SUBDIVISION REPORT

S/D 86-118 - AUTUMN CHASE ADDITION

Final Plat
SUBDIVISION REPORT

S/D No.: 86-118 Name: AUTUMN CHASE ADDITION

AUTUMN CHASE

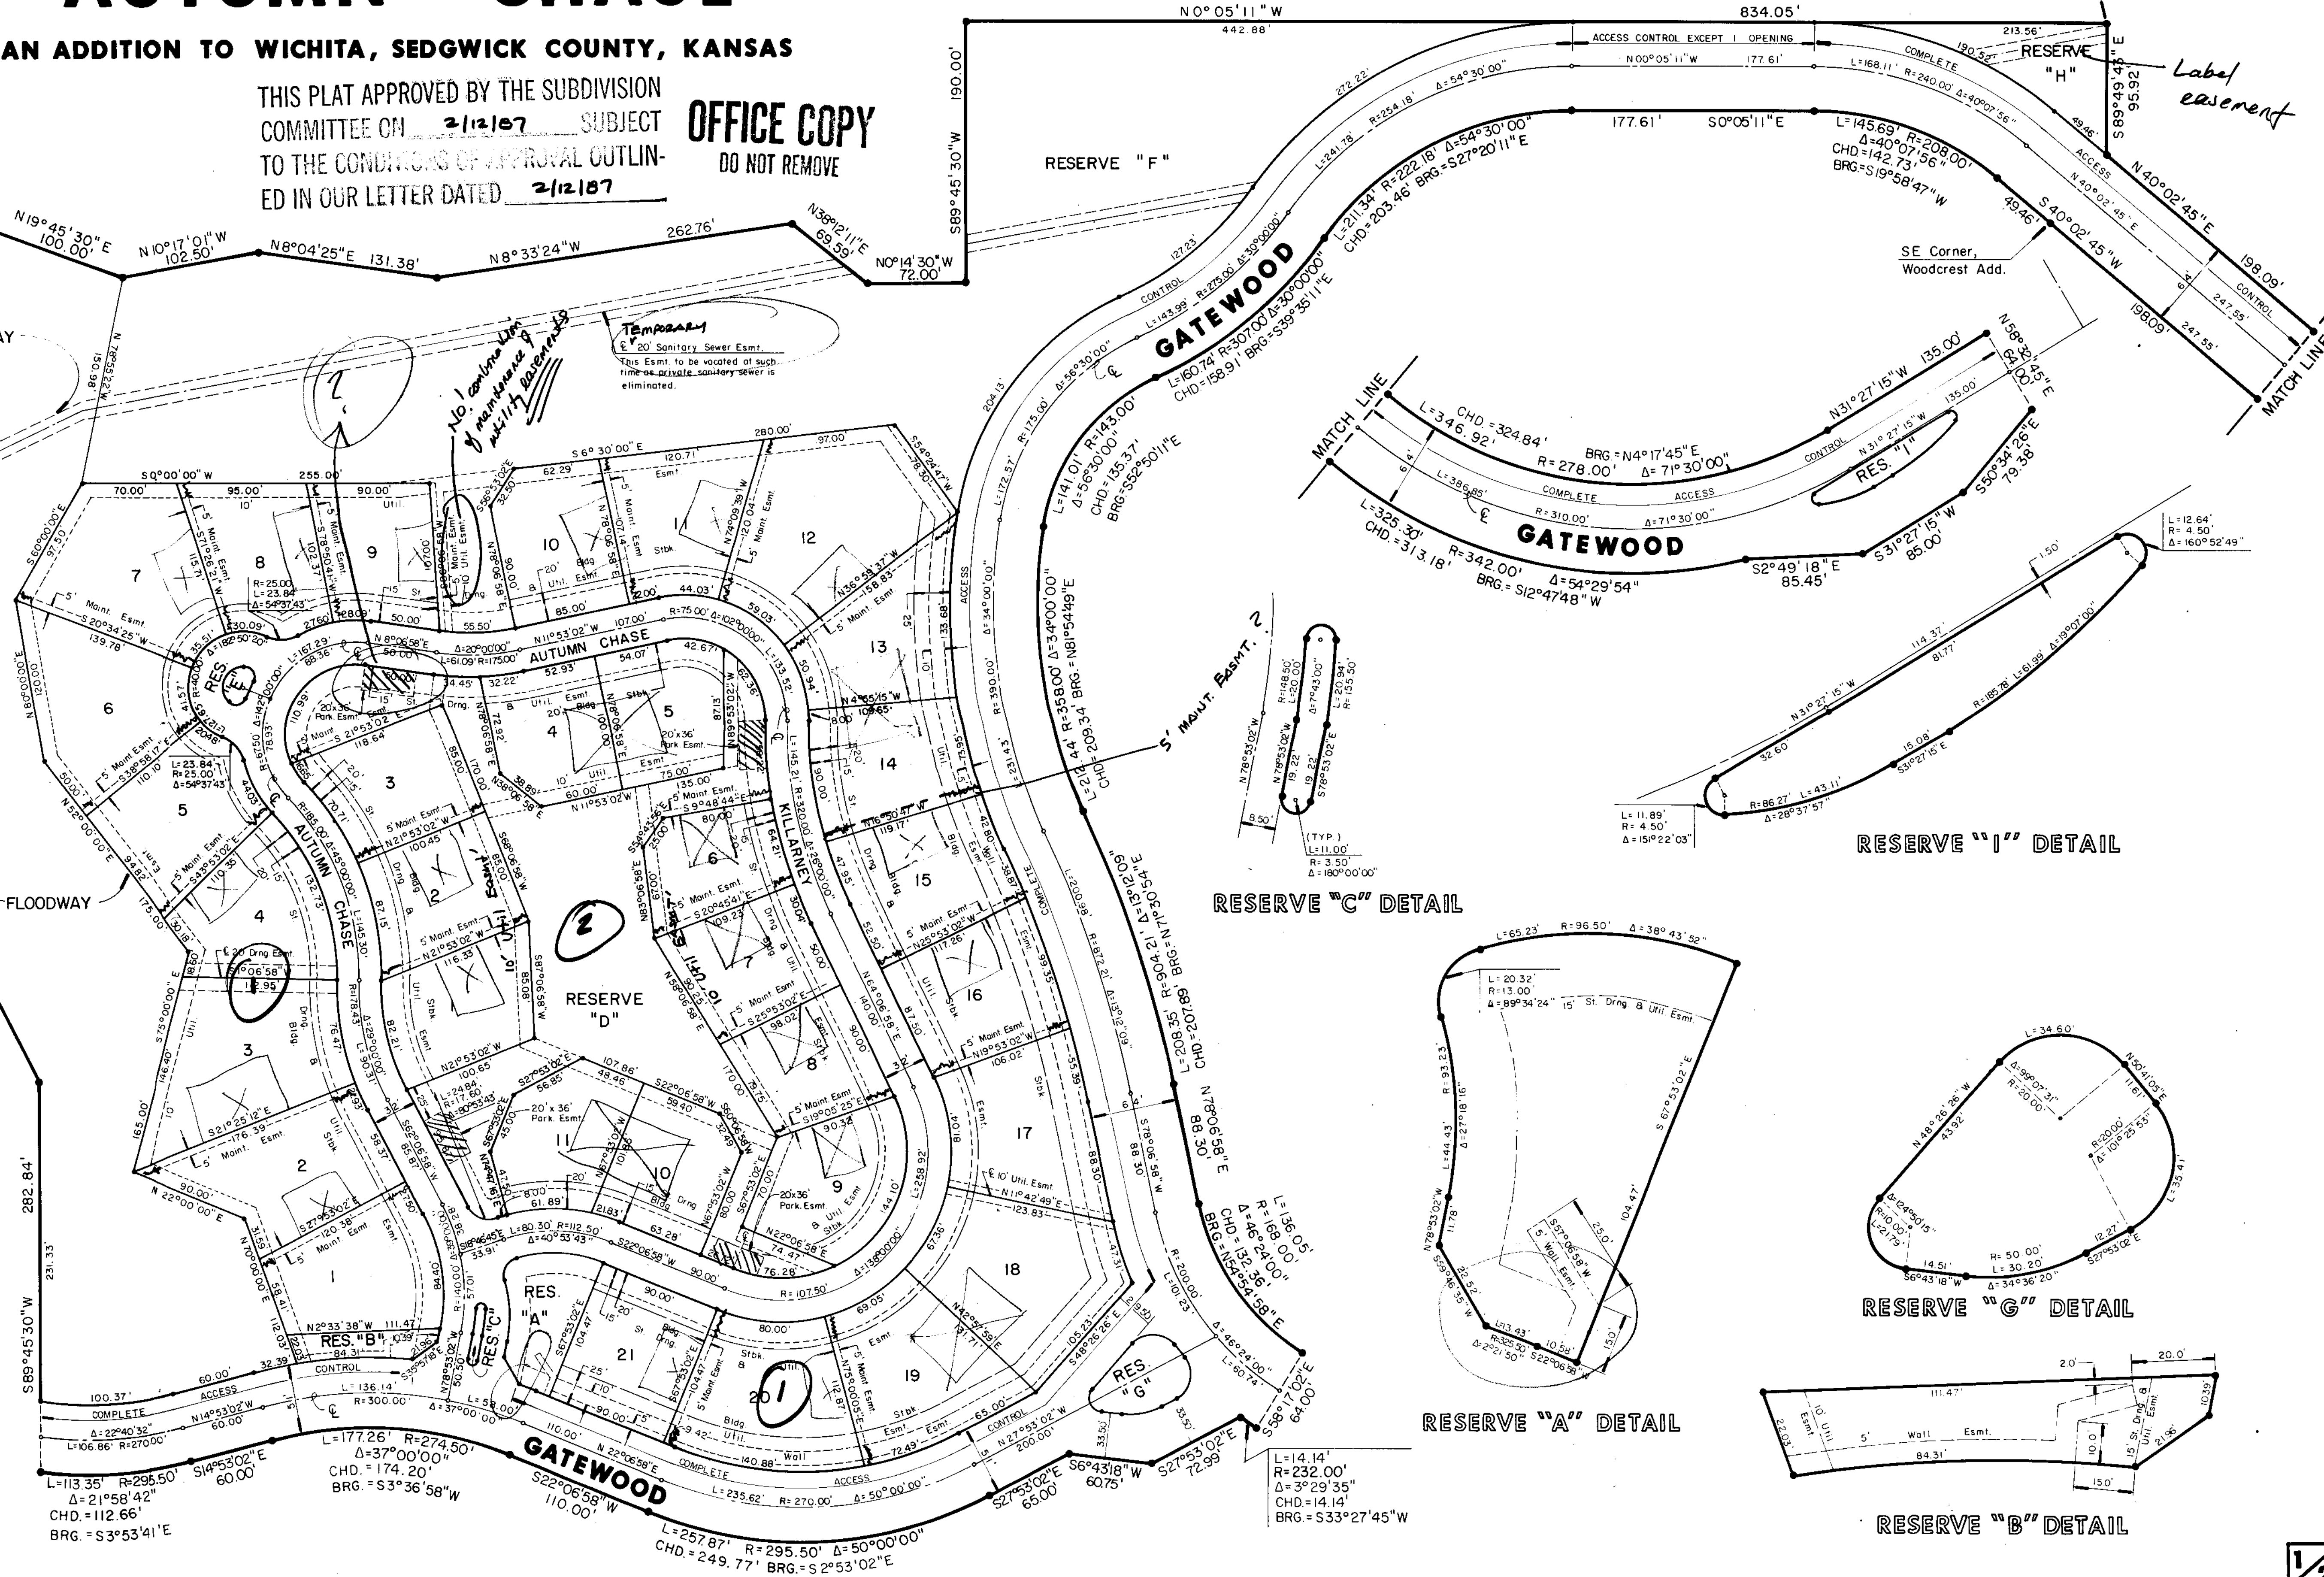
- X. On the final plat tracing, the block designations shown on the preliminary plat shall be depicted on the face of the plat.
- Y. On the final plat tracing, the type and amount of easement being platted on the east 15 feet of Reserve A shall be labeled and dimensioned.

- Z. On the final plat tracing, bearings and distances shall be provided for the centerline of the "temporary utility easement" being platted within Reserve F.

- AA. On the final plat tracing, the portion of the plat's text which references access controls, shall be amended to delete referencing the granting of access control from property which is not within the perimeter of this plat (i.e., "the easterly line of Reserve E, Woodcrest Addition).

- M. In order to provide for the side yard setbacks made necessary by the proposed zero lot line development, the final plat tracing shall specify, on the face of the plat as well as in the plat's text, that "side yard setbacks are per the requirements of the Lakepoint Community Unit Plan (DP-166) on file with the Wichita-Sedgwick County Metropolitan Area Planning Department.

- N. On the final plat tracing, a 5-foot wide maintenance easement needs to be platted on Lot 14, Block 1, if a zero-lot line unit is to be constructed on Lot 15, Block 1.

- T. On the final plat tracing, the 20-foot wide sanitary sewer easement within Reserve F shall be labeled as a "temporary utility easement". The note included with this easements labeling shall be amended to reference that the "temporary easement automatically is vacated upon abandonment of the private sanitary sewer lateral located in the temporary easement". If the 20-foot easement within Reserve H is a continuation of this "temporary utility easement", it shall be so labeled on the face of the plat and referenced in the plat's text.

- U. On the final plat tracing, the face of the plat shall not depict the continuation of the proposed 5-foot wide maintenance easement into platted street, drainage and public utility easements. The maintenance easements shall also not be shown extending into rear lot line utility easements. The maintenance easement is being platted not only for maintenance of adjacent structures, but also for a 2-foot wide roof overhang. Building overhangs are not permitted within utility, drainage or street easements.

- V. The final plat tracing shall omit the platting of the "5-foot wide maintenance easement" within the 10-foot wide utility easement adjacent to the north line of Lot 9. Roof overhangs are not permitted within utility easements. It is suggested that the 10-foot utility easement be moved 5 feet to the north within Reserve F.

- W. On the final plat tracing, the 10-foot wide utility easement being platted on the rears of Lots 6 through 11 and Lots 1 through 3, Block 2 (interior block as shown on preliminary plat), shall be labeled.

Mention state yard
reg. by virtue of C.O.P.
(from P of Prelim No.)

What!!!

What?

Label
easement
